**STATE OF NEW MEXICO
BEFORE THE ENVIRONMENTAL IMPROVEMENT BOARD**

Oil and Gas Sector – Ozone Precursor Pollutants

No. EIB 21-27 (R)

STATEMENT OF INTENT TO PRESENT TECHNICAL TESTIMONY

Figure 1. Time trace of controller LB07-PC02 from Allen *et al.* (2015). Source: Allen *et al.* (2015), supporting information, section S8 (page S-86).

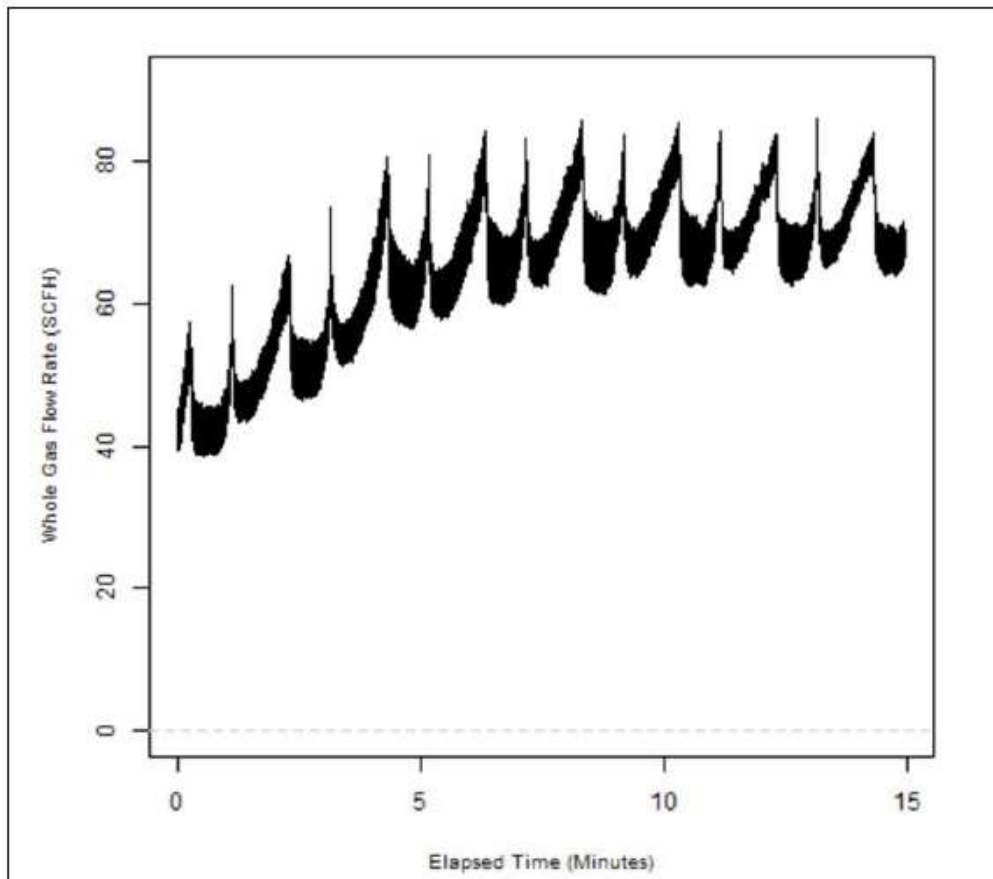
Two of these controllers are very high emitters, with emission rates over 35 scfh whole gas. All but one of these seven controllers emit more gas than the 2.2 scfh reported as the average for intermittent-vent controllers by Allen *et al.* (2015). The average emission rate for these 7 controllers was 18.0 scfh.

Figure 1: HP ranges for Caterpillar and Waukesha engines >1000 in NM subject counties (the two primary engine manufacturers for oil & gas stationary engines in high HP range). Source, NMED ICE Reductions and Costs NO2 6-4-21_erg (06-08-2021).xlsx, errors omitted.

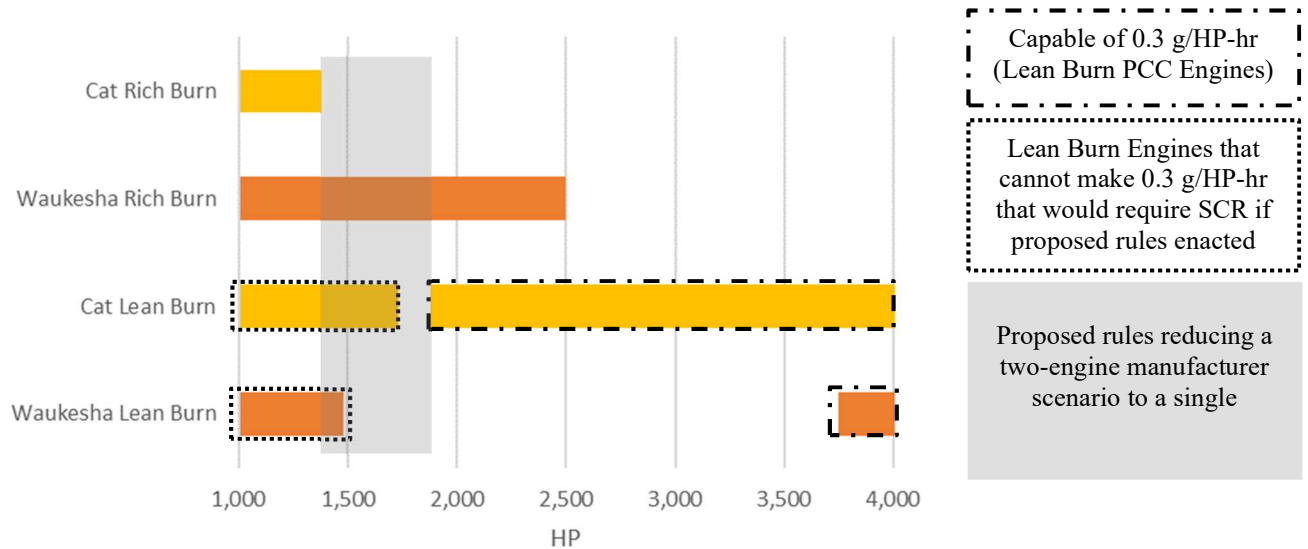
- Figure 1 below illustrates the product offerings from Caterpillar and Waukesha, which make up approximately 95% of the engines currently in use in NM subject counties, greater than 1000 HP. There are no lean burn engines capable of meeting 0.3g/HP-hr NOx under 1875 HP. Overlaying the engine count distribution (Figure 2) indicates that the largest HP application range is where

only rich burn engines can achieve the emission levels, creating a single defacto manufacturer, where otherwise two options would be available to operator.

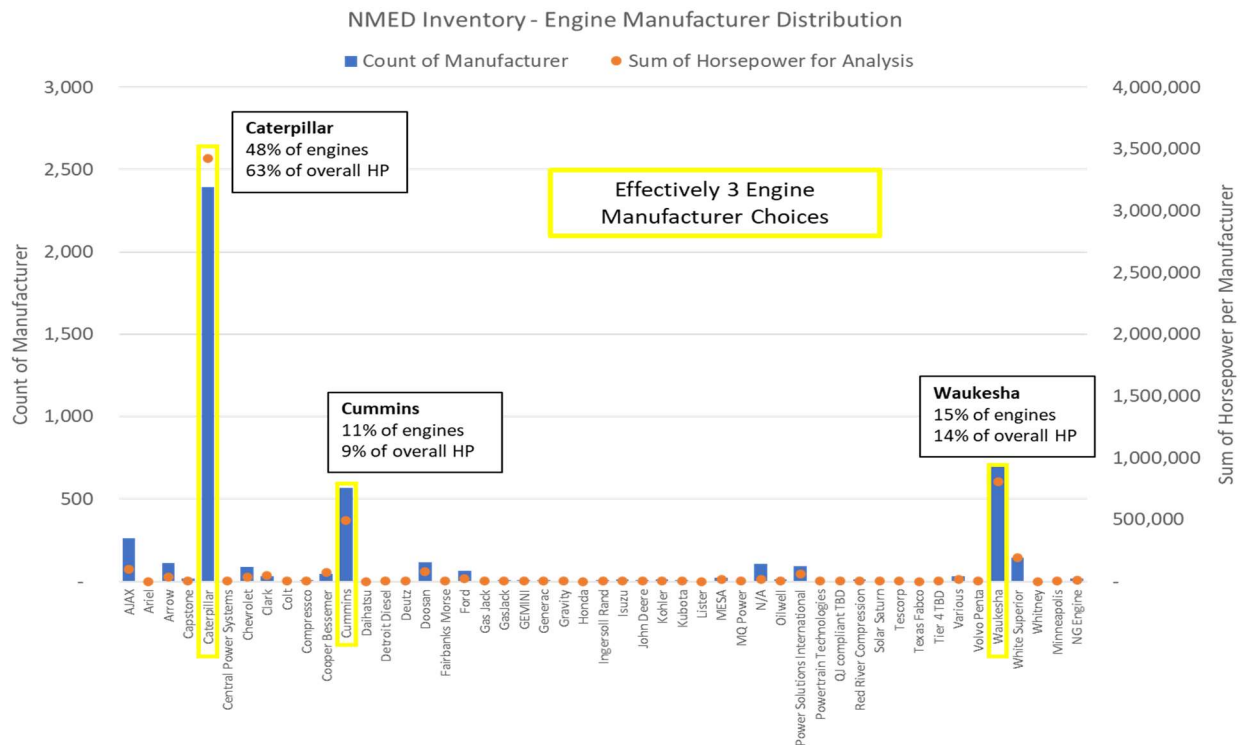
Figure 5: The data in the chart above has been determined to be inaccurate (reference Valor Memo "ERG Engine Inventory Analysis." However, as far as manufacturer distribution, it is assumed to be qualitatively and directionally correct. Source, NMED ICE Reductions and Costs NO2 6-4-21_erg (06-08-2021).xlsx.

Figure 2: Chart showing predicted VOC emission levels pre and post NMAC proposed rule.

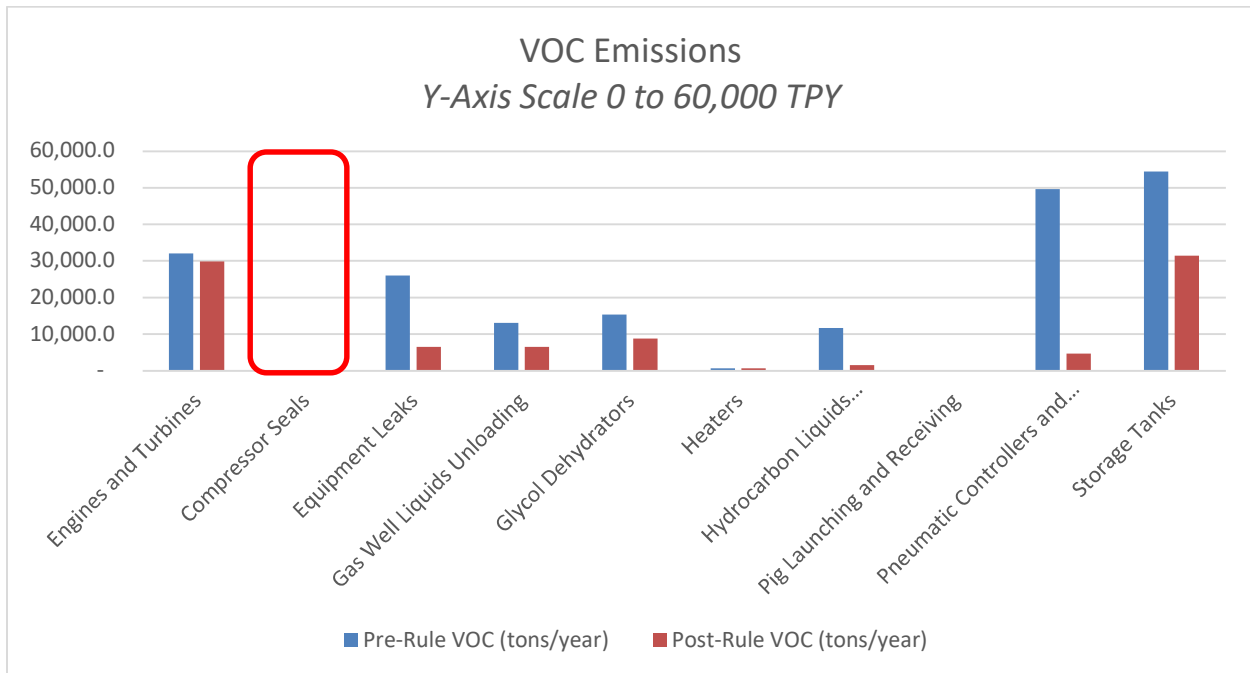
- Valor recommends that the Compressor Seals sections be completely removed from the proposed rule. According to the NMED spreadsheet, total emissions (VOCs) from compressor seals, both reciprocating and centrifugal is 0.006% of total VOC emissions from compression (figure 1), which is estimated at 13 tons/year. The proposed rules would at best, per the NMED provided analysis, only reduce the tonnage by 6 tons/year, or 0.005% of the calculated VOCs post rule (figure 2).
